## Teardown "L123 Battery Holder" Harris 12050-2005-01, RF-5911-PS002

Sheet: /  
File: CR123\_holder\_reverse\_revA.kicad\_sch

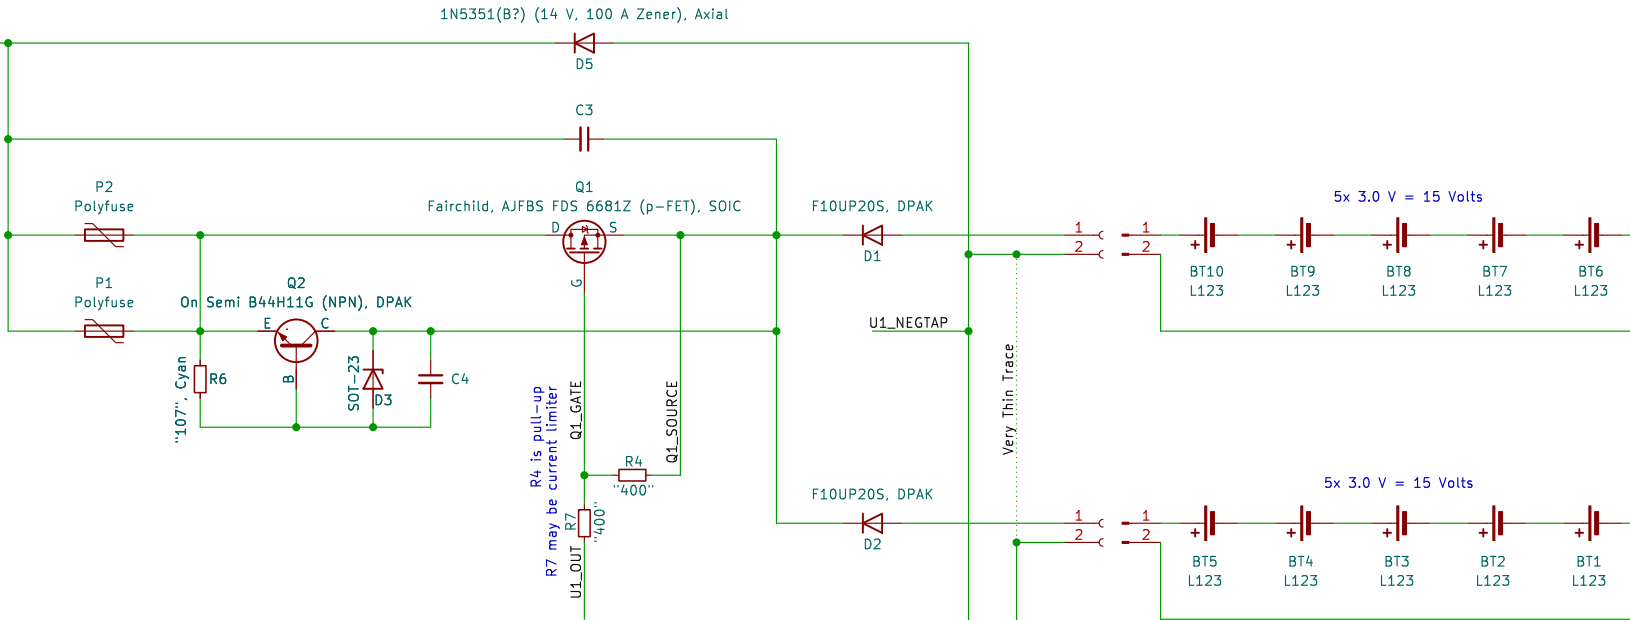
D1 and D2 prevent back-feeding into each cell string, and provide a nominal voltage of "15 V". Pretty standard "power-OR" configuration. Note the extremely thin (10 mil?) trace between the negative poles – make sure the end-application ties both "tabs" together internally.

The "original" power diode parts seem to be made by ON Semi, but ON Semi doesn't provide this part in DPAK package. Are these parts second sourced by KOI?

The Forward Voltage of the diodes is surprisingly high for a portable electronic device. At one amp, Vf is 0.75 V, which works out to 0.75 W of heat.

Q1 is a pretty standard p-FET, in SOIC package. Q1 is controlled by U1 (AEAA). U1 appears to be the only "active" part on the board. A Google search of "SOT-23-5 AEAA" returns MAX6457UKDOA-T; a Maxim Integrated "High-Voltage, Low-Current Voltage Monitors in SOT Packages". Circuit layout and other context strongly suggests this is correct.

Q2 and the surrounding components are a bit of a mystery to me. The printing/etching on D3 is unreadable, but given the package and the PCB silkscreen, I strongly suspect it's a Zener diode voltage regulator. R6 is physically a different color than the rest of the resistors on the board – maybe a "high" tolerance part? My best guess is the complex effects a crude voltage cut-off system, i.e. battery output is switched off if the cell string drops below a given voltage. BJTs are current-driven devices (unlike FETs) so there is some analog magic going on here, lending credence to the theory that R6 is some high precision device.

But why is there a full, secondary, parallel power path? Does it serve as a "backup" for the Q1/U1 complex? Or is this entirely vestigial, an artifact of the manufacturing process?

Potential evidence for the latter is the fact there are two identical fuses in parallel on the board. Putting two fuses in parallel won't result in a larger hold/break current due to rating tolerance matching issues. Fuses don't act like typical resistors; they don't "share" current. This is an extremely basic mistake. If one needs more current transfer capability, they need to specify a larger fuse.

I wonder if this board went only part-way through the manufacturing process with a BOM for the Q2 complex, including placement of P1 fuse. Then, for whatever reason, some number of assemblies were redirected to another line and populated with the BOM for the Q1 complex, which included placement of the P2 fuse – which just happened to be the same part/value as P1.

The Q2 complex (and P1) may effectively do nothing, and only exists because Harris didn't want to throw away an entire production run, or pay for manually reworking the assemblies.

D5 is presumably a reverse polarity/back-EMF protection diode. C1, C3, C4 are almost certainly some kind of decouple capacitor.
